**VSR-TSB-029**

# Vehicle Safety Recall - Technical Service Bulletin

**Attention:** Oshkosh Product Owner  
**Subject:** Bendix Pressure Switch  
**Models Affected:** Oshkosh S-Series Front Discharge Mixer  
**Model Year:** 2020  
**Date:** September 2020

## **PROCEDURE: Bendix Pressure Switch Inspection and Replacement**

Figure 1. Brake Treadle Valve

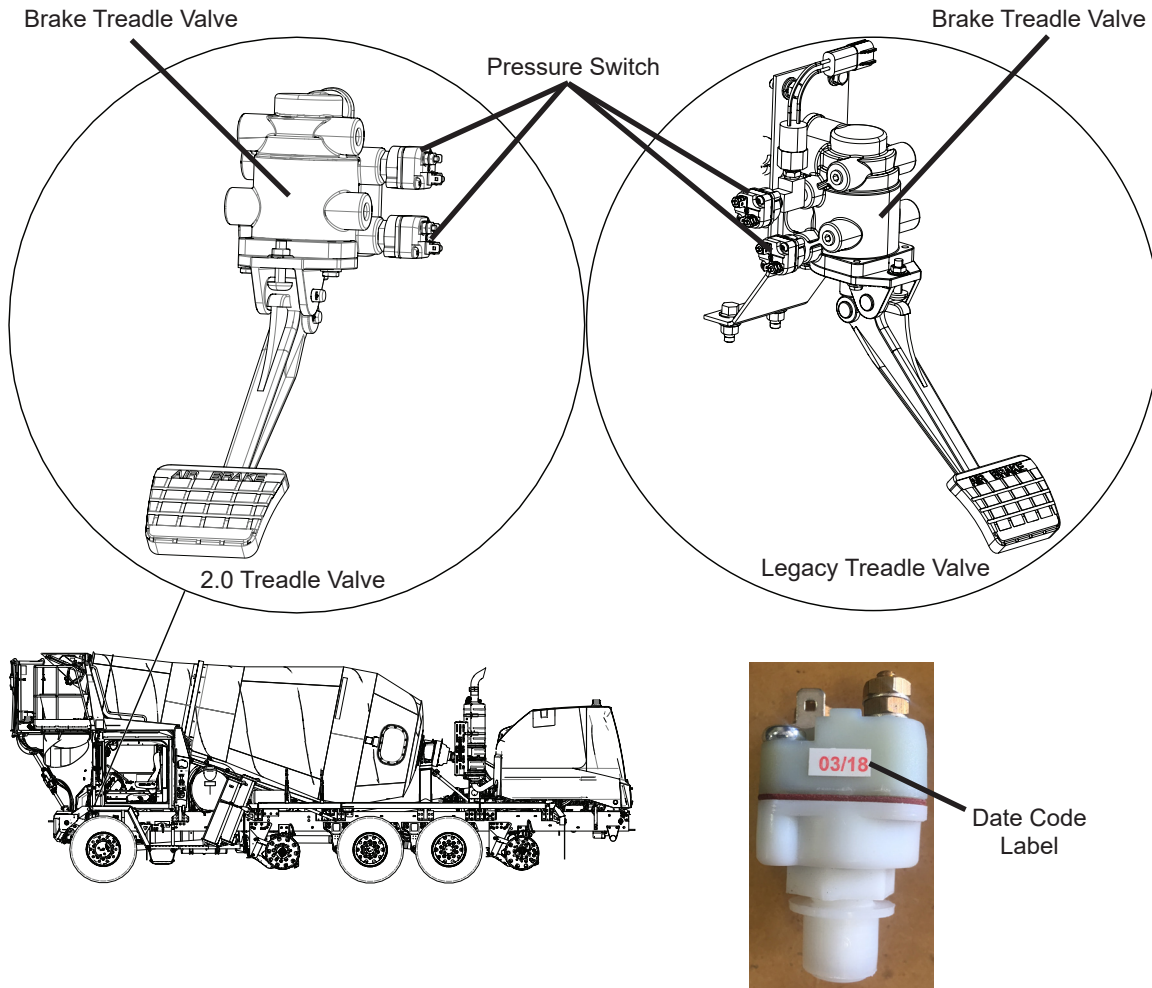
3. Locate the two Bendix pressure switches installed on the brake treadle valve, see Figure 1.
4. Check the pressure switch lot number date code label. Suspect lots include 12/19 and 01/20. See Figure 1.

- A. If either of the pressure switches lot number date code label does not include 12/19 or 01/20 this procedure is complete and no further action is required. Remove your company's Lockout/Tagout procedure. If your company does not have a Lockout/Tagout procedure, follow OSHA 1910.147 and 1910.146 Confined Space as appropriate. Remove the wheel chocks. Return the vehicle to service.
- B. If either of the pressure switches lot number date code label includes 12/19 or 01/20 or the date code label is missing **Do not run or use the vehicle**, maintain your company's Lockout/Tagout on the vehicle, and replace the pressure switch(es) per the replacement procedure.

1. Disconnect harness connections from the pressure switch.
2. Loosen and remove the pressure switch from the brake treadle valve.
3. Apply Loctite® 567 sealant to the threads of new pressure switch.
4. Install pressure switch in brake treadle valve. Final tighten pressure switch hand tight plus 2-3 turns.
5. Reconnect harness connections to pressure switch.
